ADDENDUM #2

FOR  
EXTERIOR PAINTING AT RIVERBANK HIGH SCHOOL

FOR  
RIVERBANK UNIFIED SCHOOL DISTRICT  
Bid Time and Date: April 30, 2026 at 3:00 p.m.

ADDENDUM NO.	<b>2</b>
DRAWING NO.	<b>ADD-2.3</b>

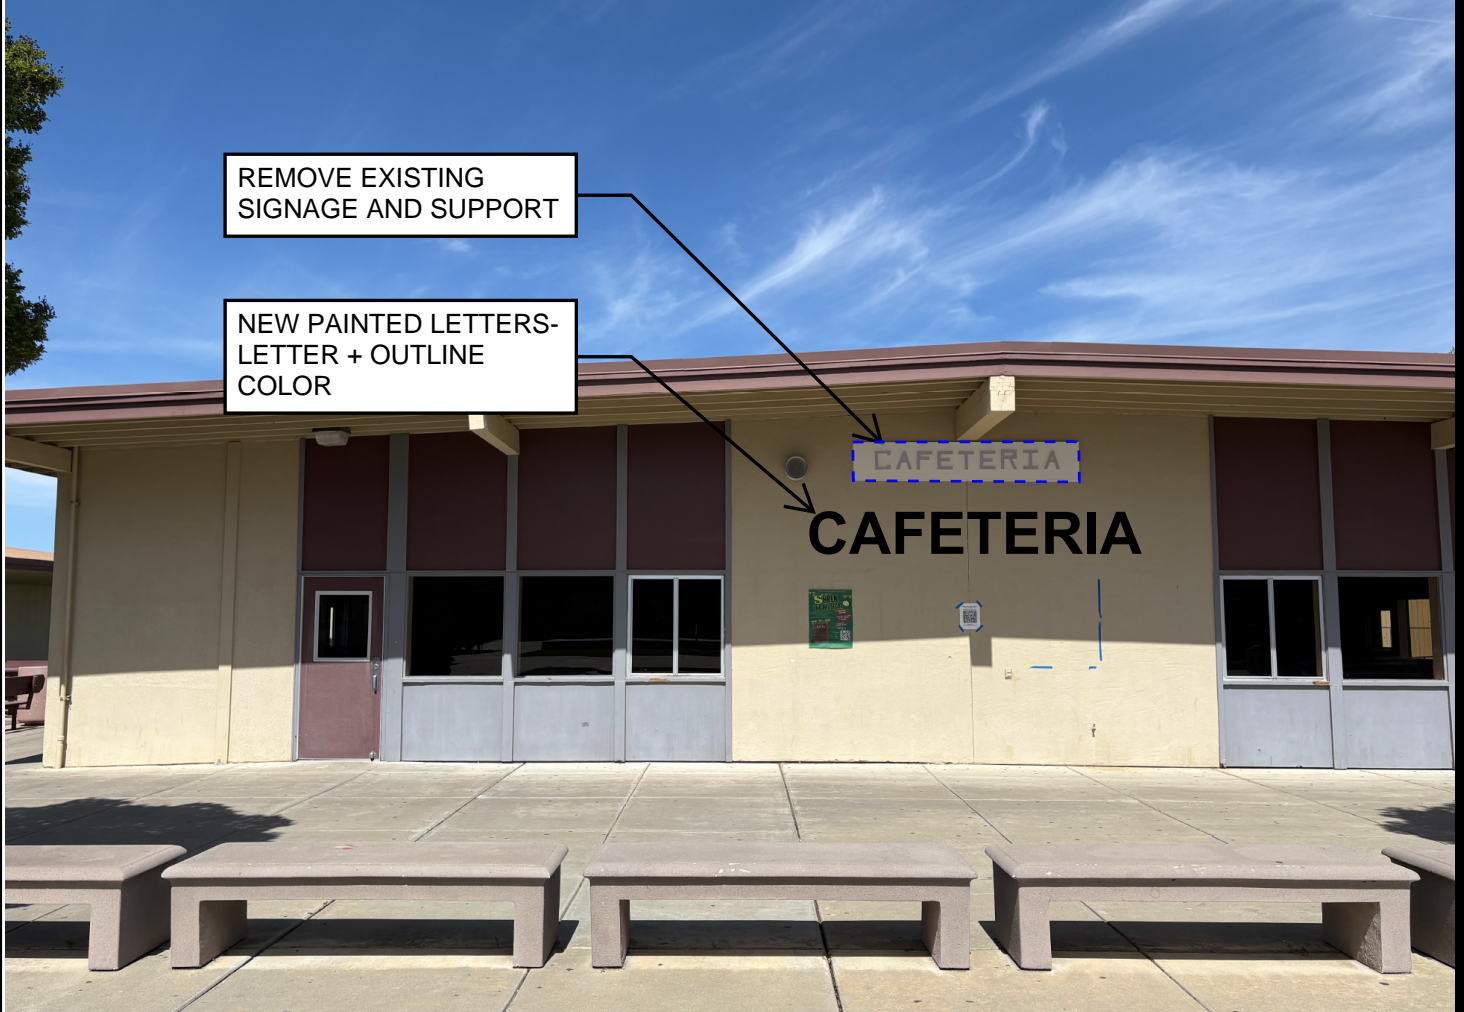
- Item 6.: Reference Site Plan, Sheet CS;  
The Contractor shall include painting of columns, gutters and downspouts at Building “N”. Do not paint bottom of roof panels. See attached Drawing ADD-2.3.

PAINT ALL SURFACES AT SHADE STRUCTURE

DO NOT PAINT BOTTOM OF METAL ROOF PANELS - PAINT EXPOSED BEAMS
